RE: Daviess County Bridge – Daviess County, Missouri
MoDOT Project BRO-B031(34)
Addendum No. 1

Addendum No. 1**Daviess County Bridge BRO-B031(34)
Daviess County, Missouri**

DAVISS COUNTY BRIDGE 35900061 BRO-B031(34)

INTERMEDIATE BENT DETAILS

SECTION C-C

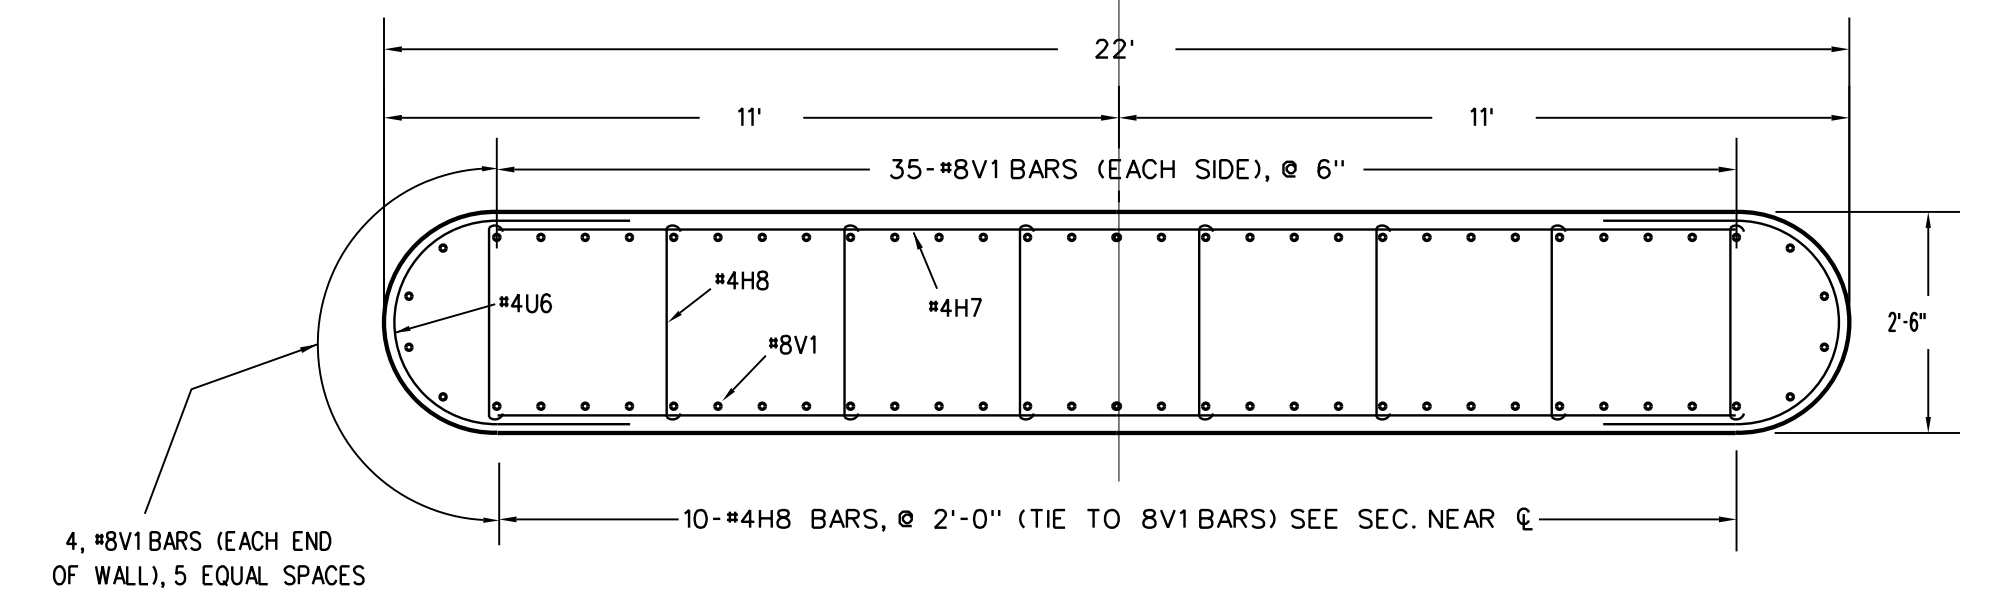
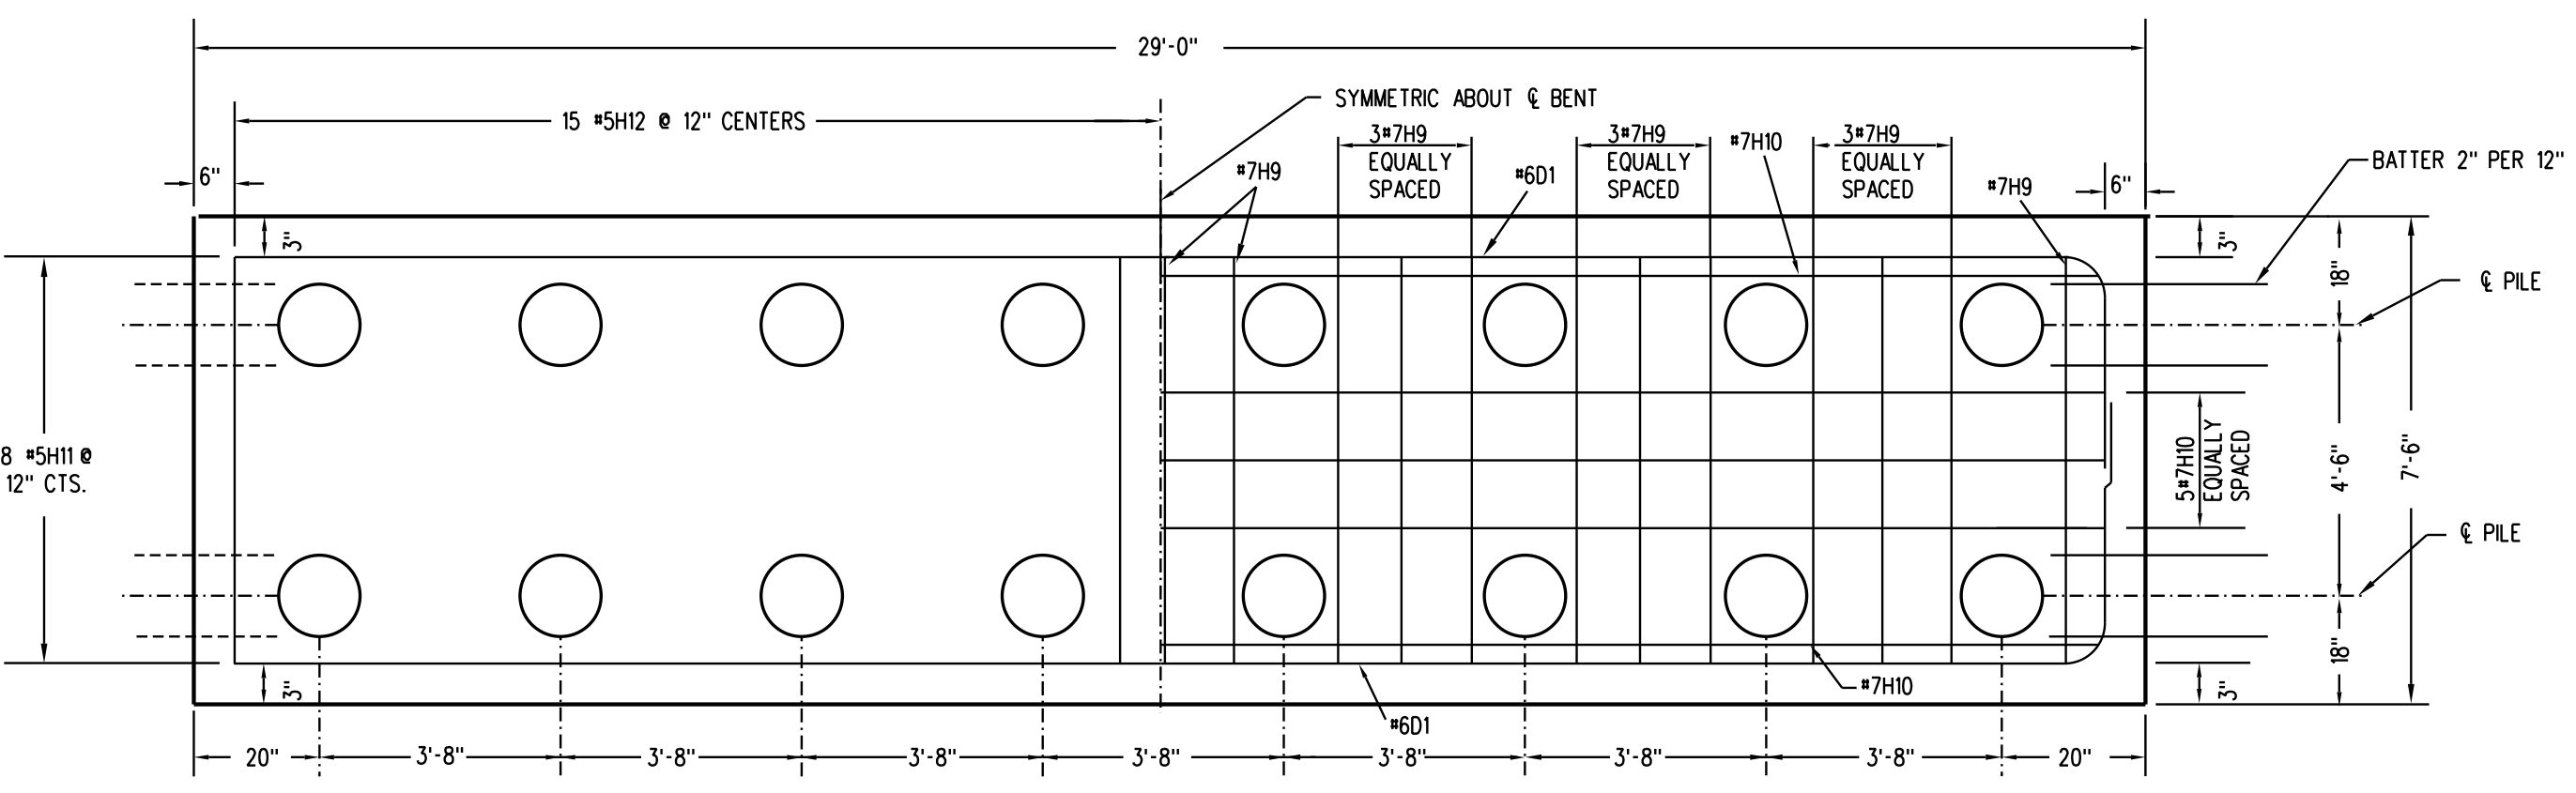
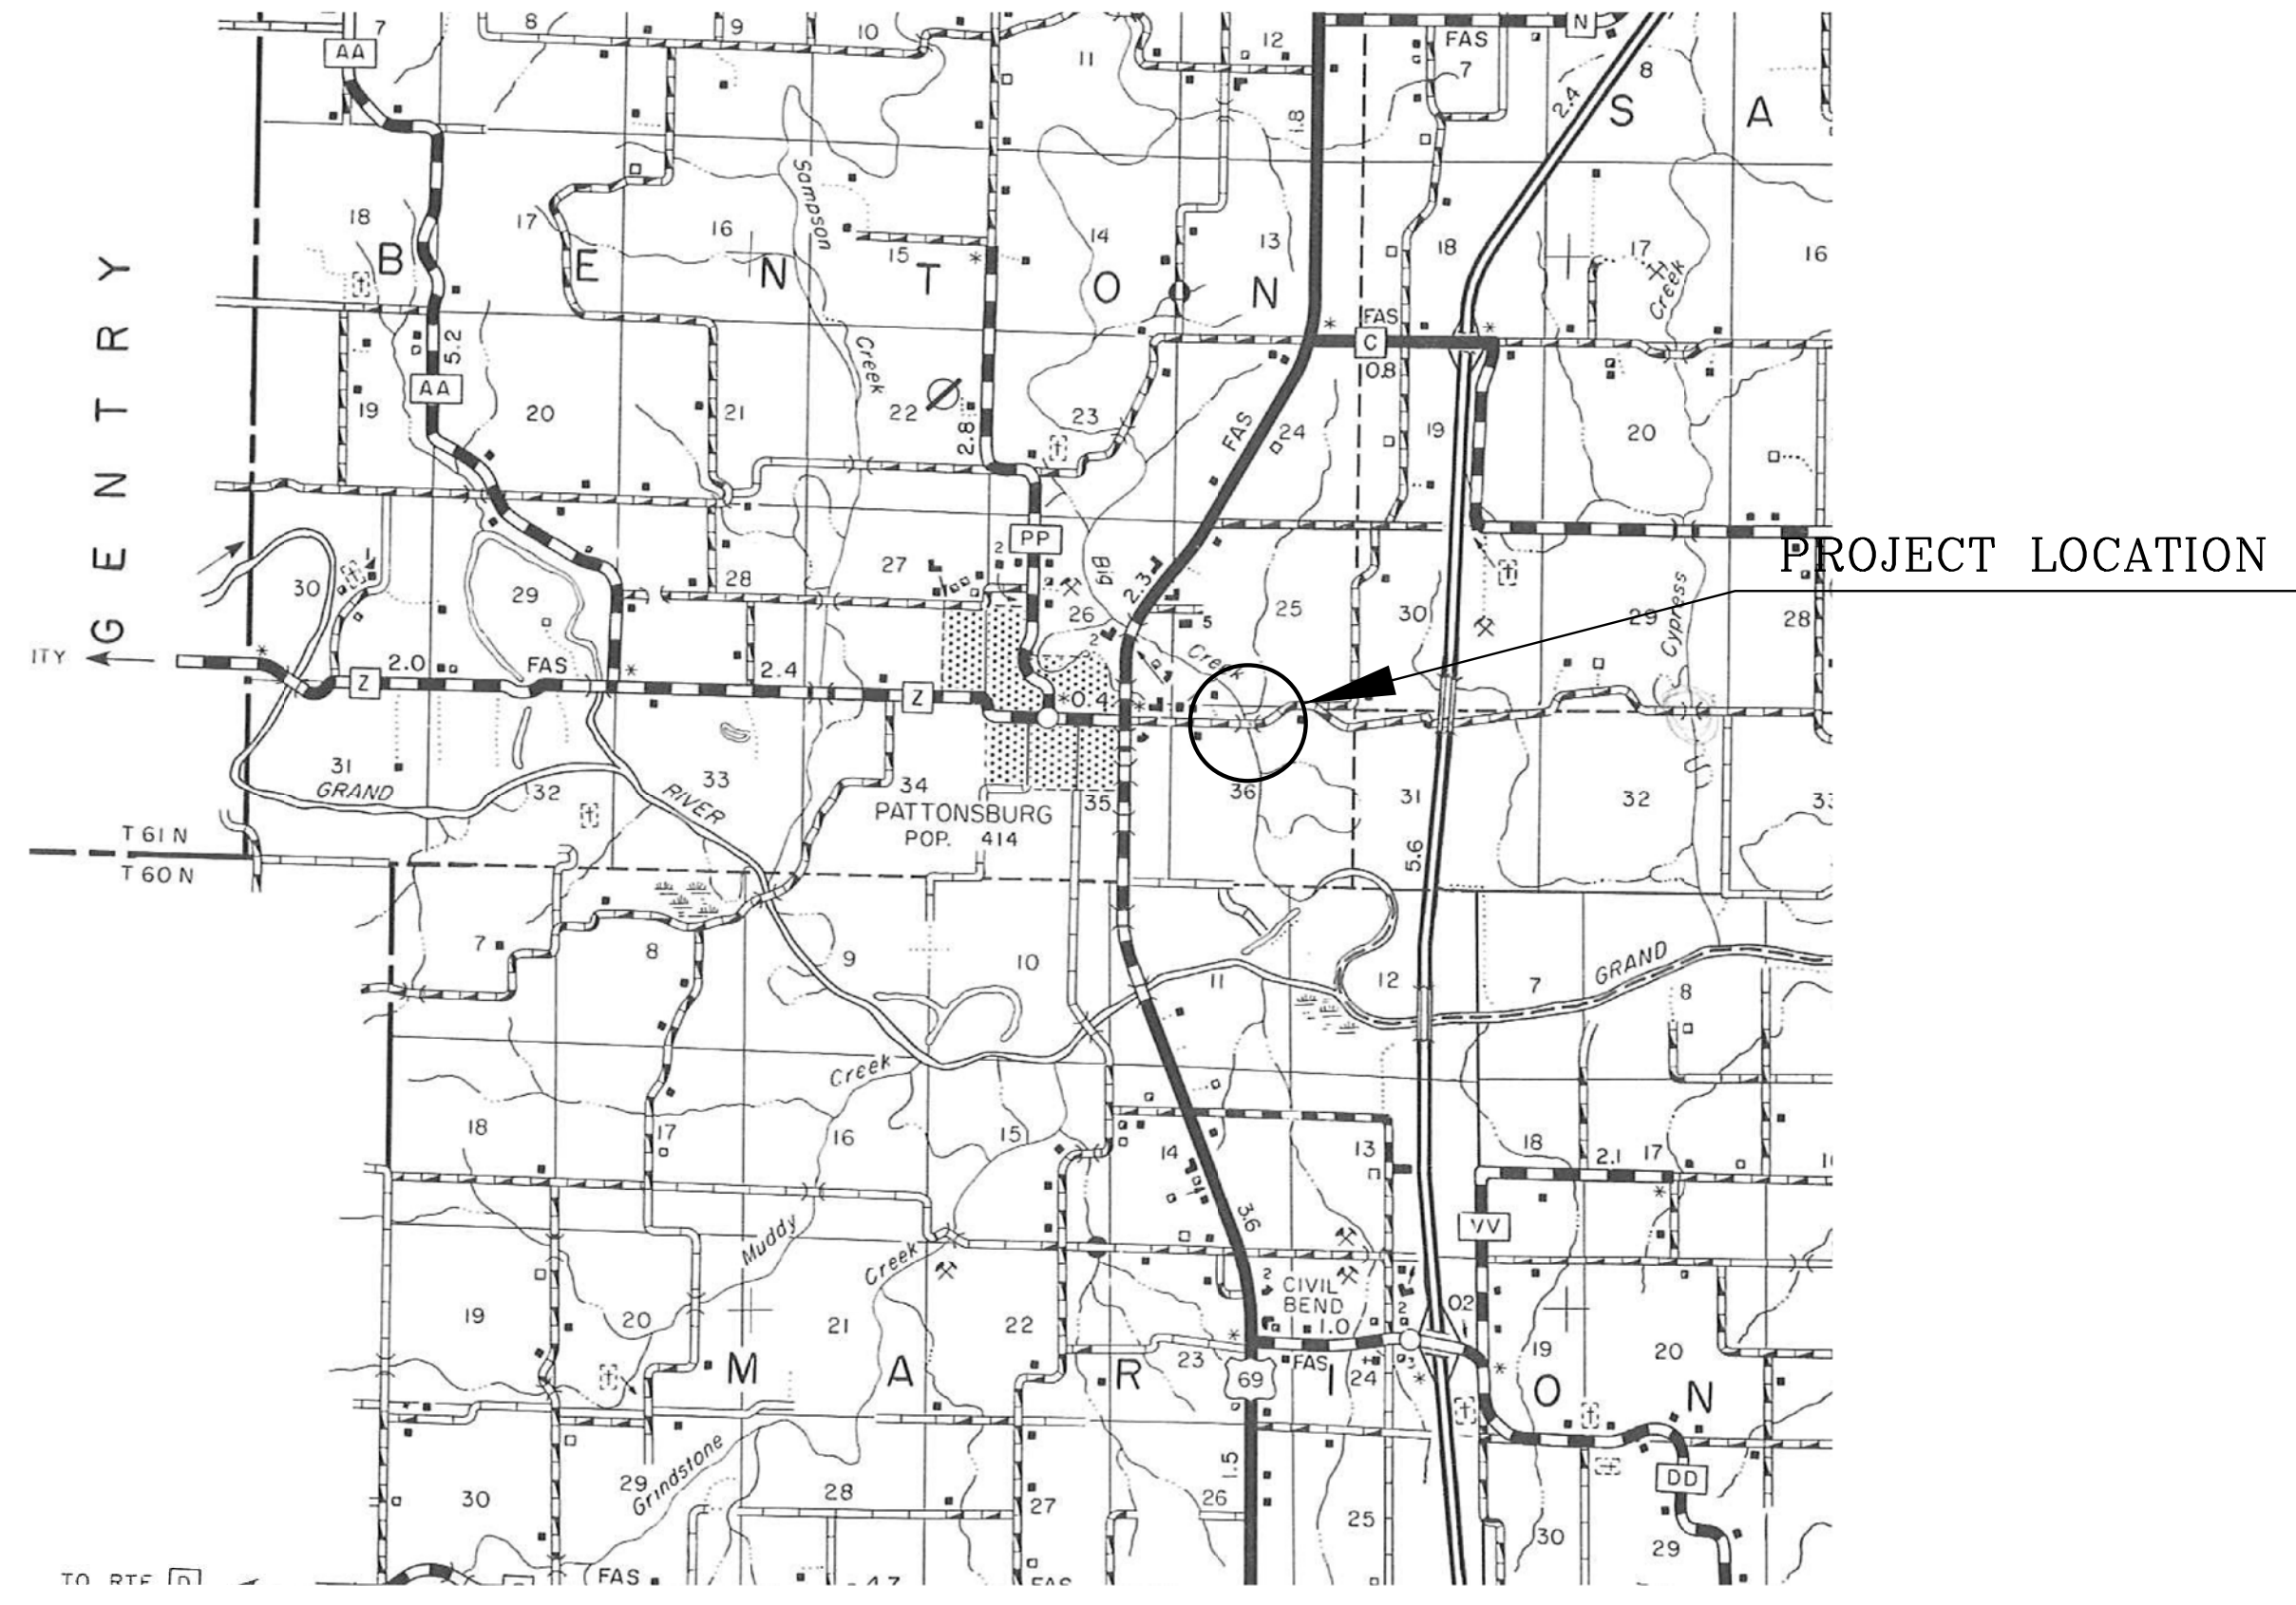
1. Replace sheet 6 of 22 with the enclosed. Elevation table has been corrected.
2. Attached you will find a complete replacement set of plans that are more legible. No other corrections have been made.

TABLE OF ELEVATIONS		
ELEVATION	BENT 2	BENT 3
A	738.90	738.90
B	741.90	741.90
C	775.35	775.35
D	778.60	778.60
E	778.73	778.73
F	778.60	778.60
